**METROPOLITAN GOVERNMENT OF NASHVILLE AND DAVIDSON COUNTY**

**STAFF RECOMMENDATION**  
**1906 Blair Boulevard**  
**August 19, 2020**

**Application:** Demolition; New Construction—Infill  
**District:** Belmont-Hillsboro Neighborhood Conservation Zoning Overlay  
**Council District:** 18  
**Base Zoning:** R6  
**Map and Parcel Number:** 10416002100  
**Applicant:** Will Jenner of Jenner Design, LLC  
**Project Lead:** Sean Alexander, sean.alexander@nashville.gov

<p><b>Description of Project:</b> A proposal to demolish a non-contributing building and construct a new one. The new building will be two-and-one-half-stories tall with a cross-gabled form.</p> <p><b>Recommendation Summary:</b> Staff Recommends approval of the proposed infill construction with the following conditions:</p> <ol style="list-style-type: none"><li>1. The finished floor height shall be consistent with the finished floor heights of the adjacent historic houses, to be verified by MHZC staff in the field; and</li><li>2. The front setback shall be consistent with the setbacks of the adjacent historic houses, to be verified by MHZC staff in the field; and</li><li>3. The width of the building shall be reduced to

1916 Blair Boulevard. Thirty-nine foot (39') wide structure on a fifty-five foot (55') wide lot.

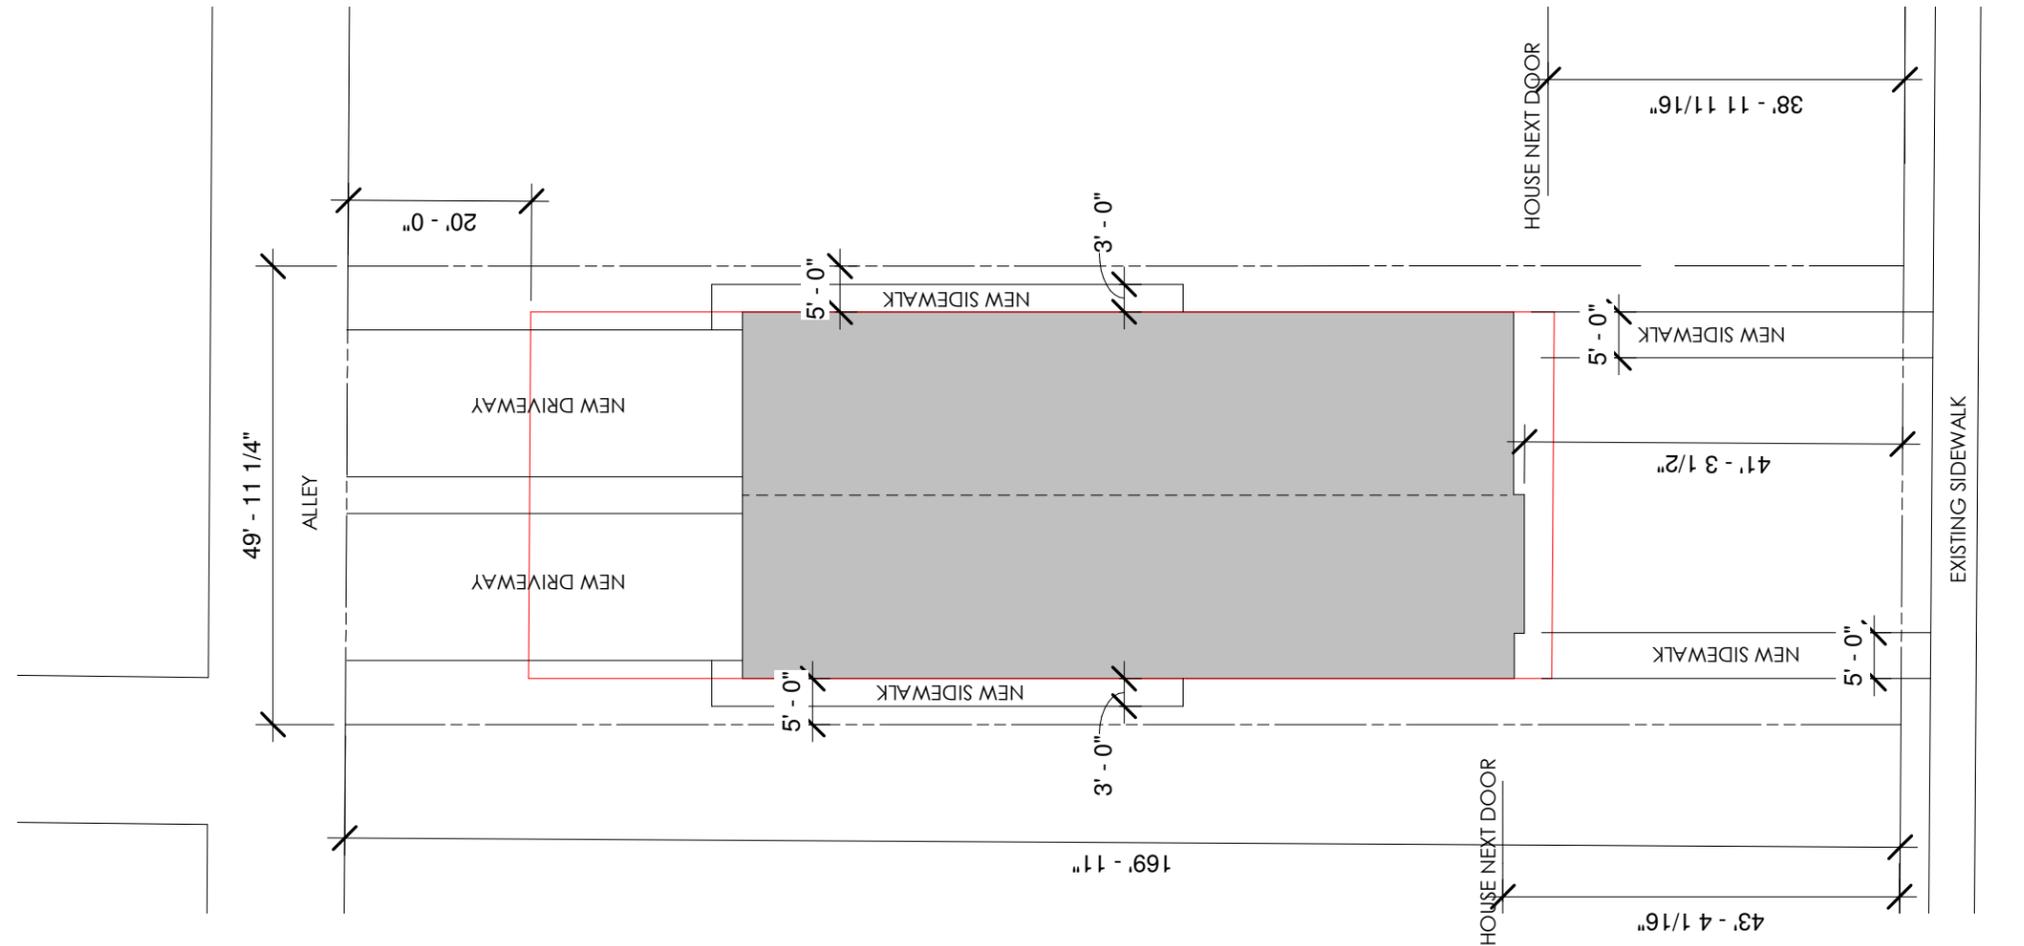
Nearby houses on fifty-foot wide lots (the same width as 1906 Blair Boulevard) are thirty feet (30’) and thirty-two feet (32’) wide. The two-and-one-half-story house two lots to the left at 1916 Blair Boulevard is thirty-nine feet (39’) wide, on a lot that is fifty-five feet (55’) wide. Staff finds the width of the proposed house to be inappropriate as it is wider than even 1916 Blair Boulevard which is on a wider lot.

similar. Therefore, staff suggests that the structure at 1906 Blair Boulevard should be ten percent (10%) narrower as well, or thirty-five feet (35') wide.

With a condition that the infill at 1906 Blair Boulevard is reduced to thirty-five feet (35') wide, staff finds that the height and width of the infill will be compatible with the surrounding context and that it will meet section II.B.1.a. and b.

SITE PLAN

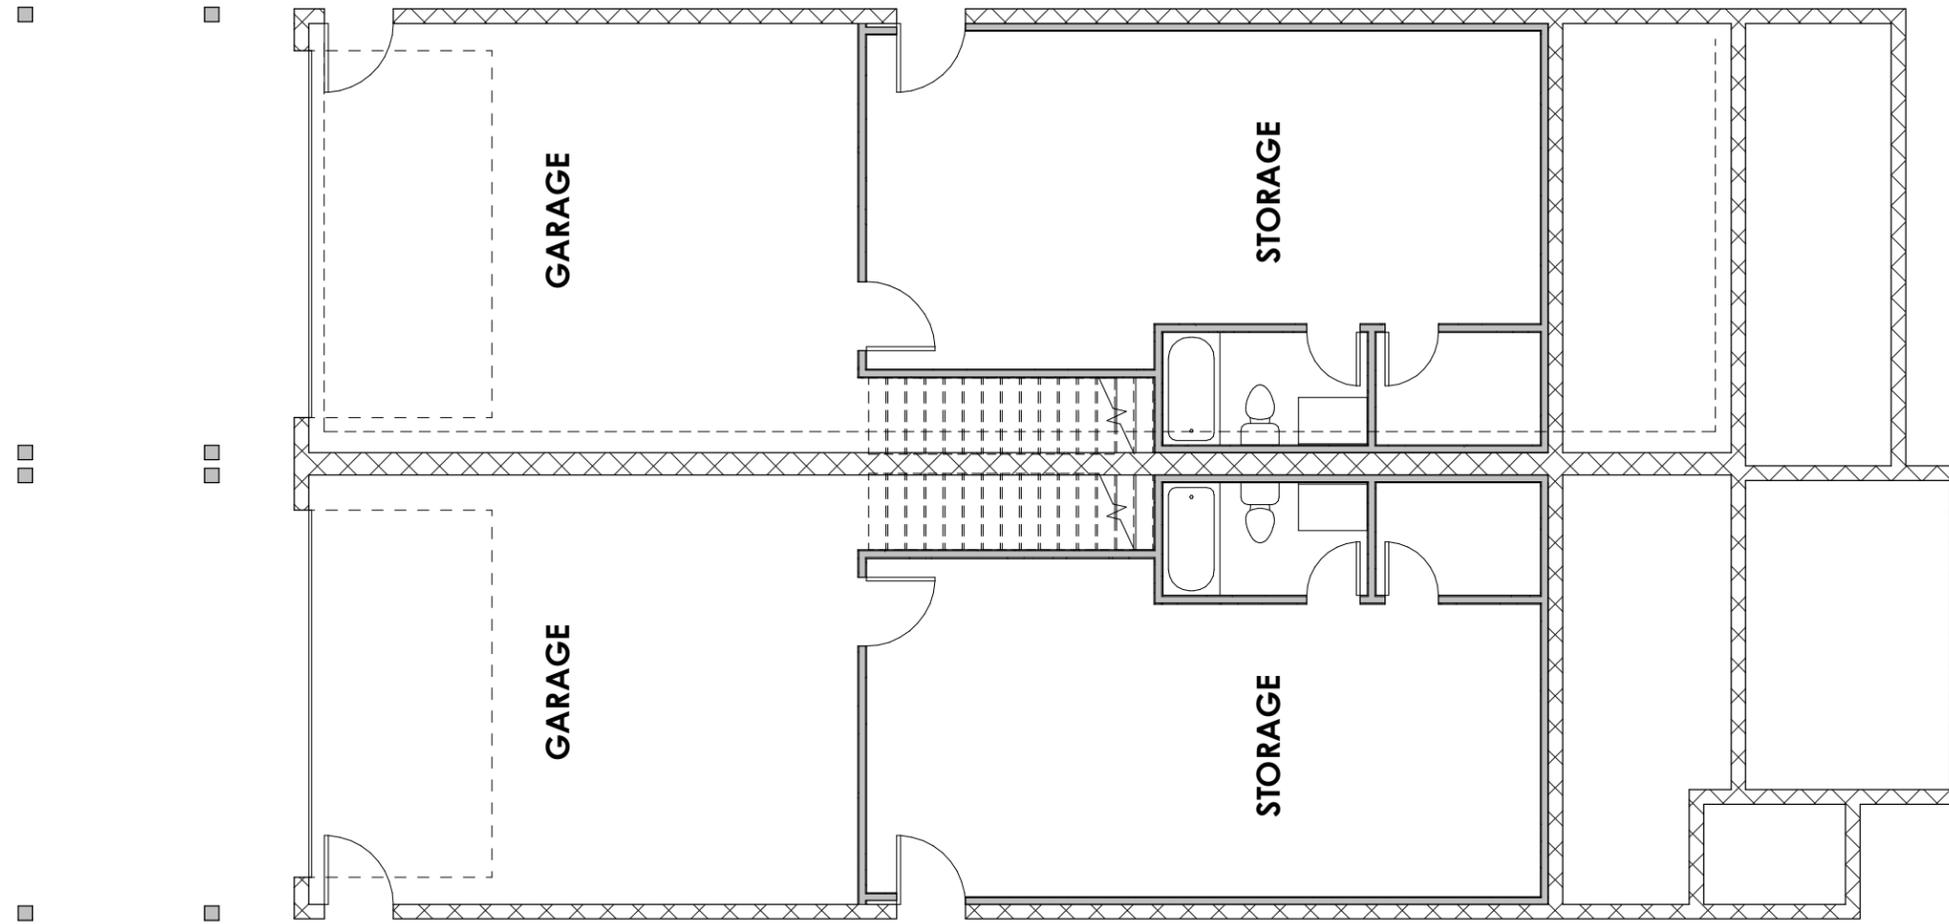
Setback & Rhythm of Spacing: The infill is proposed to be located with its front wall in line between the fronts of the two adjacent buildings houses, matching their setbacks. The house will be centered on the lot with side setbacks of five feet (5') on both sides. Typically, historic houses on comparable lots have side setbacks of eight feet (8') to ten feet (10'). Staff finds that the rhythm of spacing between the infill and the adjacent buildings will be narrower than is typical of the surrounding area. Staff recommends that the width of the structure shall be reduced to thirty-five feet (35'), resulting in side setbacks of seven feet, six inches (7'-6").

Appurtenances & Utilities: The proposal includes two walkways from the front of the building to the sidewalk at the front of the lot, which are common features in the neighborhood. The location of the HVAC and other utilities was not indicated in the proposal. Staff asks that the HVAC be located on the rear façade, or on a side façade beyond the midpoint of the house. The project meets section II.B.1.h.

1. The finished floor height shall be consistent with the finished floor heights of the adjacent historic houses, to be verified by MHZC staff in the field; and
2. The front setback shall be consistent with the setbacks of the adjacent historic houses, to be verified by MHZC staff in the field; and
3. The width of the building shall be reduced to thirty-five feet (35'); and
4. The window and door selections and roof color shall be approved prior to purchase and construction; and
5. The HVAC units shall be located on the rear of the building or on the side behind the midpoint.
